# UNITED STATES PATENT AND TRADEMARK OFFICE

APPLICATION NO.	FILING DATE	FIRST NAMED INVENTOR	ATTORNEY DOCKET NO.	CONFIRMATION NO.
10/728,331	12/04/2003	Theodore E. Anvick		7370

**Office Action Summary**

Artzer (U.S. Patent No. 4,336,676)

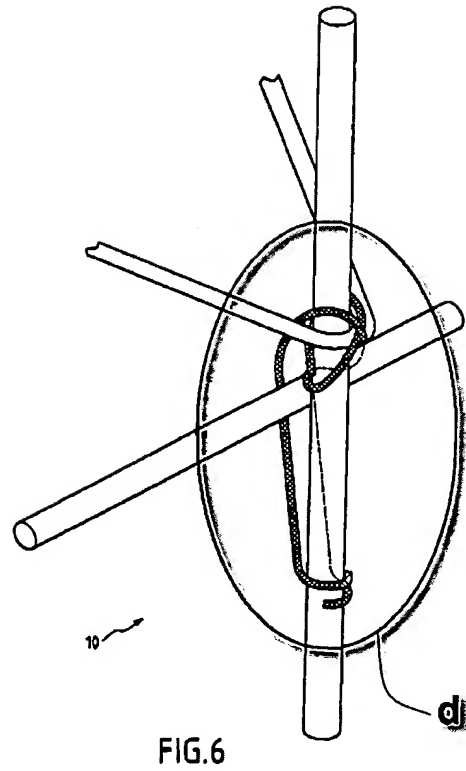
Regarding claim 7, Durand in Figures 4 and 6 discloses an aperture device (d) as discussed above and further disclose that at least one element (4, 5) is comprised of curvilinear reinforcement elements (4) but does not disclose that the reinforcing elements is of a material of the group consisting of mineral, metal, fiber, or chemical. However, Artzer in Figure 12 discloses an aperture device where at least one element (130) is comprised of curvilinear reinforcement elements that are inherently of metal (Col 9, Ln 58-60). Therefore, it would have been obvious to a person having ordinary skill in the arts at the time of the applicant's invention to modify the device of Durand to include at least one element comprised of curvilinear reinforcement elements of a material of metal as taught by Artzer to provide reinforcement elements that can be welded (Col 9, Ln 58-60).

Durand (U.S. Patent No. 6,691,486 B1)

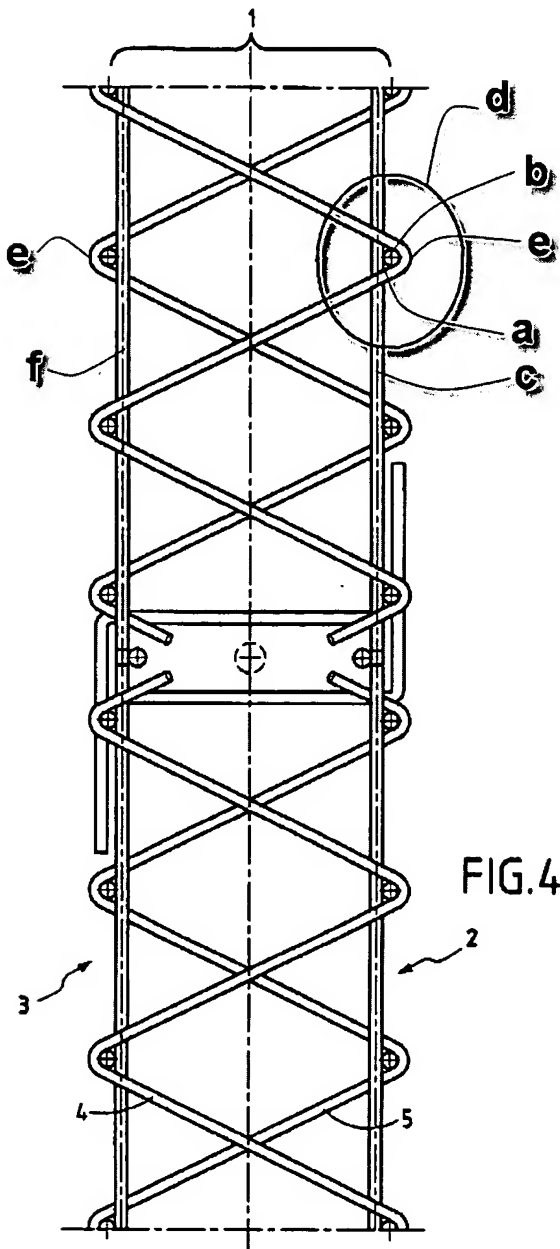
Regarding claim 1, Durand in Figures 4 and 6 discloses a static structural reinforcement connecting element device (d) comprised of an aperture (a); a predetermined disposition of reinforcing members (c, f, 4, 5) providing means to attain higher ductility, and composite action in structures. The phrase “providing means to attain higher ductility, and composite action in structures” is regarded to as functional language, and while features of an apparatus may be recited either structurally or functionally, claims directed to an apparatus must be distinguished from the prior art in terms of structure rather than function. Examiner refers Applicant to MPEP §2114. Furthermore, Durand’s reinforcing members are capable of performing the functions stated above.

Regarding claim 2, Durand in Figures 4 and 6 discloses an aperture device (d) wherein said aperture device (d) is comprised of any arrangement of elements of a truss (2) when at least one continuous web element (4, 5) is formed to a curvilinear waveform providing means for containment or girding of reinforcement (b) within the area bonded by one or more truss elements (4, 5, c).

Regarding claim 9, Durand in Figures 4 and 6 discloses an aperture device (d) wherein the aperture (a) is formed by the innermost cross-sectional face of a web vertex (e) and the outermost cross-sectional face of an inwardly mounted cord (c), leaving sufficient space for insertion of substantially perpendicular reinforcement (b), providing means for unification of a predetermined plurality of trusses, and reinforcement elements in longitudinal, lateral, and transverse axis. The phrase "providing means for unification of a predetermined plurality of trusses, and reinforcement elements in longitudinal, lateral, and transverse axis" is regarded to as functional language, and while features of an apparatus may be recited either structurally or functionally, claims directed to an apparatus must be distinguished from the prior art in terms of structure rather than function. Examiner refers Applicant to MPEP §2114. Furthermore, Durand's aperture is capable of performing the functions stated above.

Regarding claim 17, Durand in Figures 4 and 6 discloses an aperture device (d) wherein said cincturing aperture (a) can be provided by rigidly affixing said web element (4, 5) to at least two cords (c, f) by bending and said web element (4, 5) is rigidly affixed to one or more chord (c, f) elements in opposition forming one or more apertures (a) in parallel for insertion of reinforcement elements of an elongated and sinuous nature to span between said apertures interconnecting, and girding, and cincturing said spanning reinforcement to said elongated lattice framework containing a plurality of said cincturing apertures along its span. The phrase "for insertion of reinforcement elements
